Expert Opinion Report - Rectification

10-12 View Point Road, McCrae

PSM5226-005R 11 June 2024

Inset 2: Excerpt from CivilTest report 1222044-1 Issue 2 (5 December 2022) (Document 2, pdf page 4)

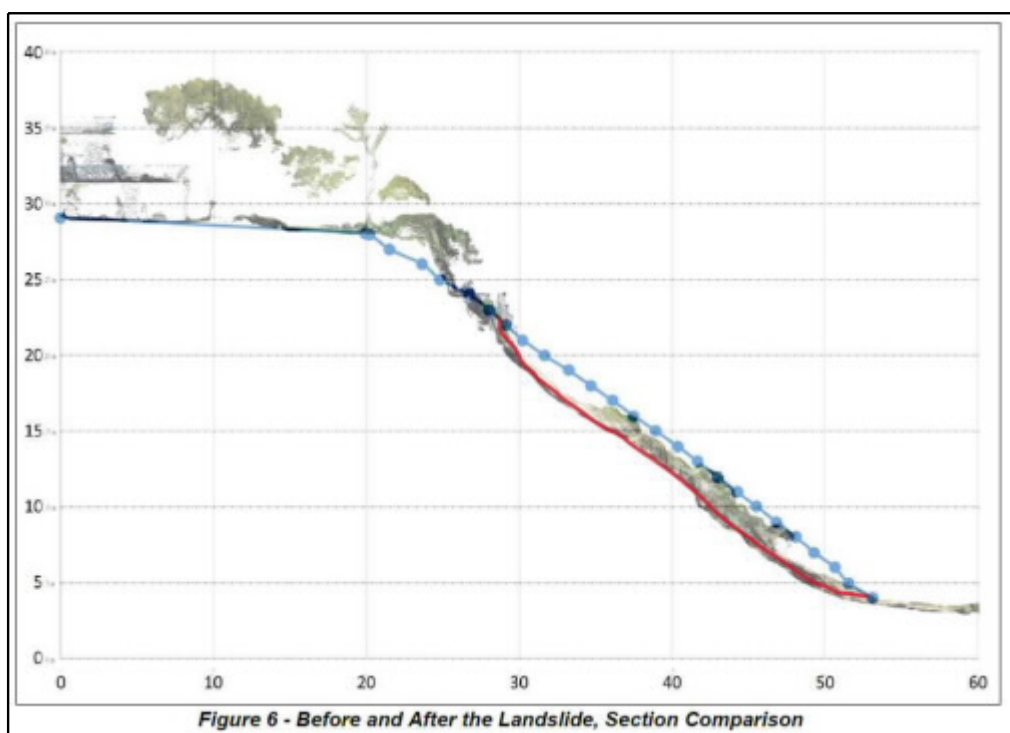
- (d) The steep head scarp depicted in CivilTest drone survey (Inset 2) and models (ref) is an artefact of creating a thick cross section line from the drone model. i.e. the head scarp feature depicted by CivilTest at the crest of the escarpment does not exist on Site (refer to Paragraph [9(a)]).

Inset 3: CivilTest description of debris flow as “fill” (Document 9, pdf page 3)

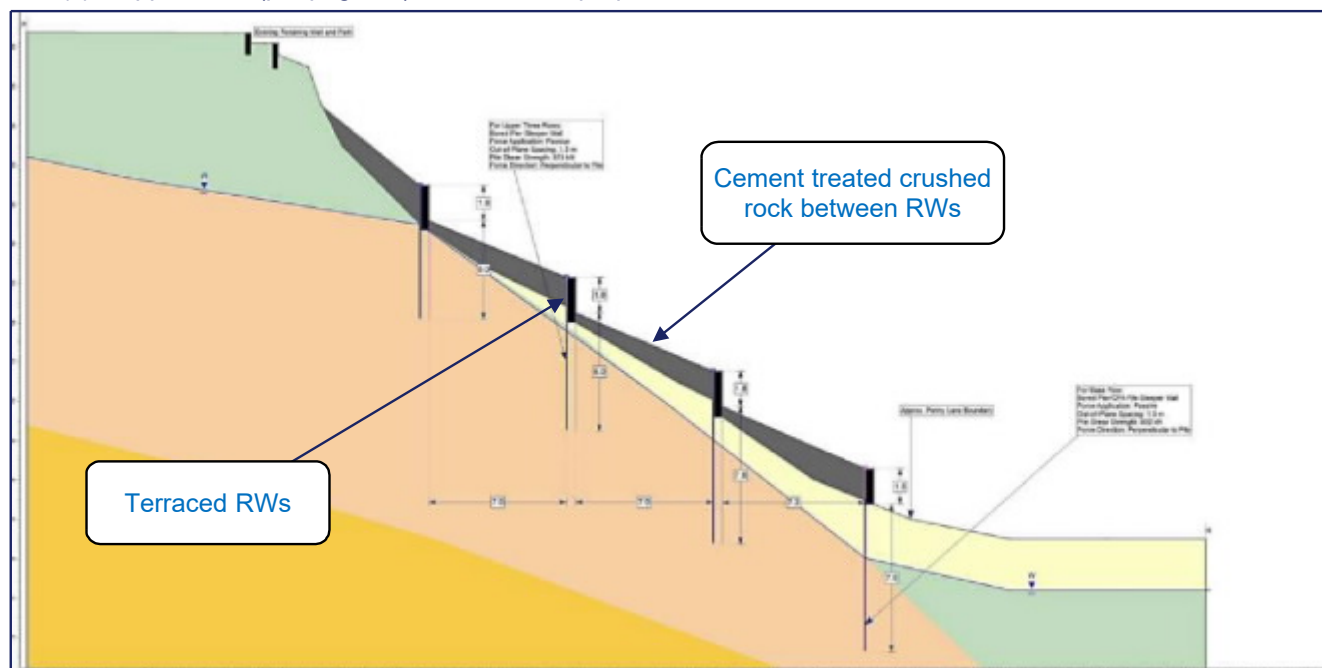
10. Documents 9 of the Brief is the CivilTest Land Stability Assessment report 1222044-3 (24 March 2023). The report indicates to me:
- (a) Boreholes drilled at the toe of the slope in Penny Lane encountered landslide debris, Inset 3 (Section 2.1, pdf page 3).

- (b) Boreholes 1 and 2 encountered landslide debris 1.2 m and 0.7 m thick respectively (Appendix C, pdf pages 29 to 30). I have assumed that all fill reported at the toe of the slope is landslide debris.
